## SPENARD ROAD Reconstruction

### Hillcrest Drive to Benson Boulevard

MOA Project Number 03-22b

#### MEETING NOTES

**Table 1. Comments Written On Meeting Graphics**

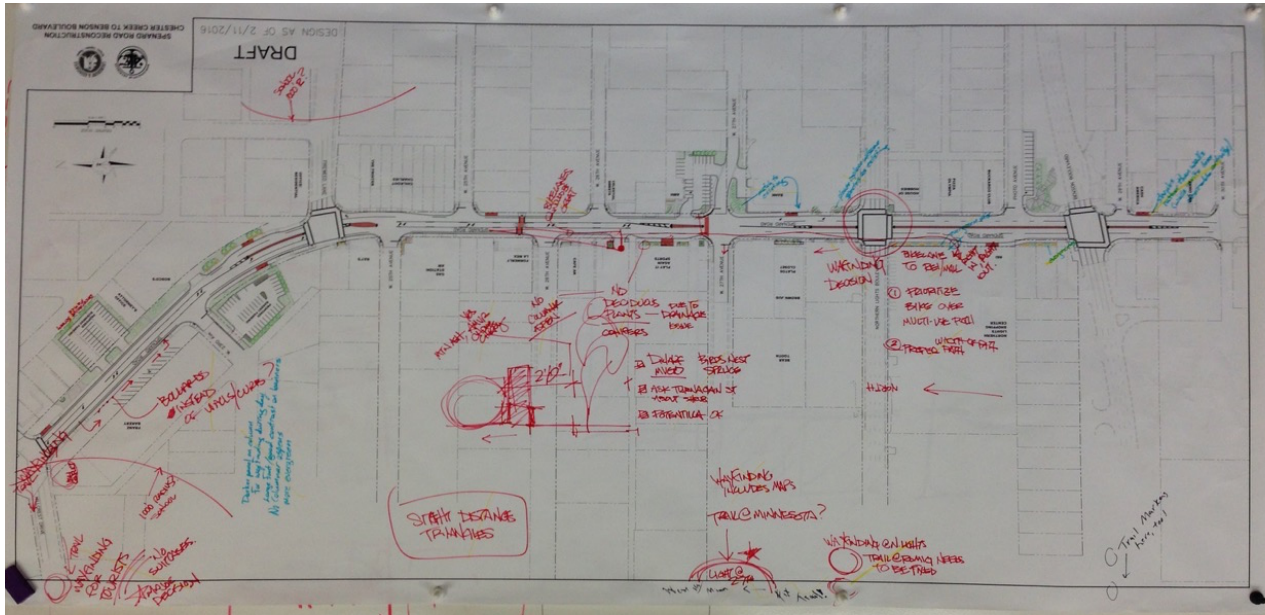
| Location                  | Landscaping Comment   | Design Comment  | Other | Miscellaneous |
|---------------------------|---|---|-------|---------------|
| 30th to Benson            | Shrubs rather than walls.<br>Walls invite less desirable activity.  |   |       |               |
| Benson to Northern Lights | Evergreens in front of REI building and along parking area.<br><br>Wayfinding decision at Northern Lights Blvd.<br><br>In Plaza area – bright lights for safety! Potential for homeless issues. | Bike lane to REI/Mall.<br><br>Right in/Right out.<br><br>Prioritize bike over multi-use trail.<br><br>Prefer width of path. |       |               |
| Northern Lights to 27th   | At Northrim – replace plantings with same species as existing.  |   |       |               |

| Location                          | Landscaping Comment   | Design Comment  | Other | Miscellaneous                              |
|-----------------------------------|---|---|-------|--|
| 27th Avenue to Fireweed Lane      | <p>No deciduous plants in front of Play it Again due to drainage issue. Conifers at Play it Again.</p> <p>Dwarf Mugo.</p> <p>Birds nest Spruce.</p> <p>Ask Turnagain St about Shrubs</p> <p>Potentilla OK.</p> <p>No columnar aspen.</p> <p>Yes to Mtn Ash, AMVR Chokecherry.</p>   | <p>Bike lanes would be great.</p> <p>Bike lane adjacent (left of) right turn from Spenard to Fireweed to eliminate bike/auto conflicts with turn lane.</p> <p>Where is parking (on map near attorney's office)?</p> |       | Drive in theater at Chilkoots parking lot. |
| Fireweed Lane to Hillcrest Street | <p>Low maintenance. Who maintains?</p> <p>Trail wayfinding for tourists so there will be no one with suitcases in the roadway. There is a major decision place at Spenard and Hillcrest. Direct towards trails (West High hill/Spenard Hill to Chester Creek trail).</p> <p>Use bollards instead of walls/curb?</p> <p>Add decorative fence to screen parking lot from neighbourhood.</p> |   |       |  |

| Location | Landscaping Comment  | Design Comment                             | Other | Miscellaneous  |
|----------|--|--|-------|--|
| All      | <p>More wayfinding signs</p> <p>Sight distance triangles</p> <p>Wayfinding includes maps</p> <p>Wayfinding at N. Lights</p> <p>Darker panel on column for wayfinding during the day. Large font/good contrast on banners.</p> <p>No columnar aspens, more evergreen.</p> | <p>Lower speed limit to 30 mph please!</p> |       | <p>Trail at Romig needs to be fixed.</p> <p>Minnesota to West Highway – fix the trail!</p> |
